Wavelength Consideration of 100GBASE-FR1 and 100GBASE-LR1 for Uncooled DFB Laser Operation over Industrial Temperature

IEEE P802.3cu, September 2020

Proposed changes

Dispersion Penalty Specification of $|TDECQ - TECQ| \leq 2.5$ dB

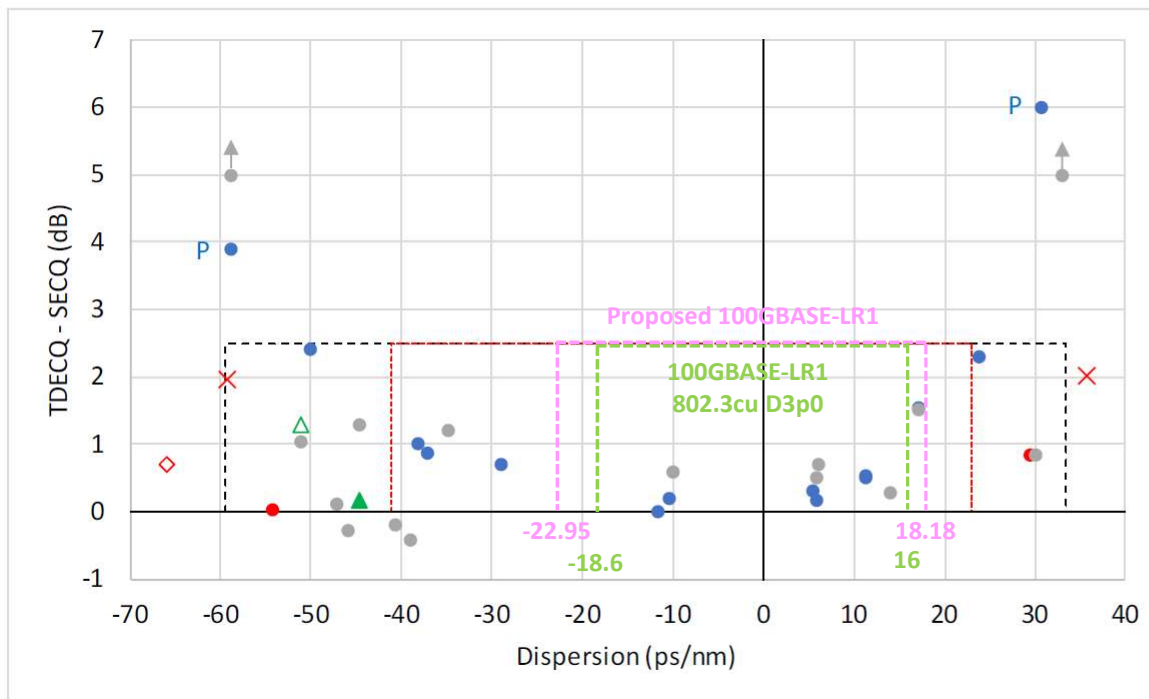
As the dispersion range is increased by the proposed wavelength relaxation for single wavelength, could the dispersion penalty spec of $|TDECQ - TECQ|$ be met for the power budget consideration?

The dispersion penalty $|TDECQ - TECQ|$ of ≤ 2.5 dB could be met with sufficient margin for 100GBASE-LR1 after the wavelength range relaxation.

- There is no significant impact to dispersion penalty according to the studies summarized in next slide. Propose no change to the dispersion penalty specification

Remain unchanged

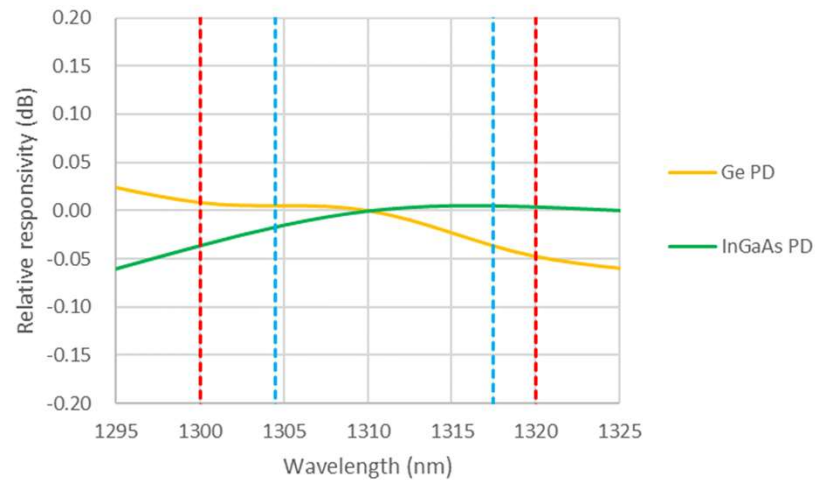
Interop the revised Tx specification with current and the previously deployed Rx specification could be of concern

Also, there is negligible impact on the receiver sensitivity from the wavelength range change as illustrated by two typical implementation of photo detectors below, one is surface normal type InGaAs PD while the other is edge coupled Ge PD. The data indicates the wavelength dependence of relative response from the Rx showing less than 0.05dB variation between the current and proposed ranges.

The link budget is essentially dependent on TDECQ and Rx sensitivity performance. As we are not changing the TDECQ nor the dispersion penalty specification, there should be no concern on interoperability issue from TDECQ.
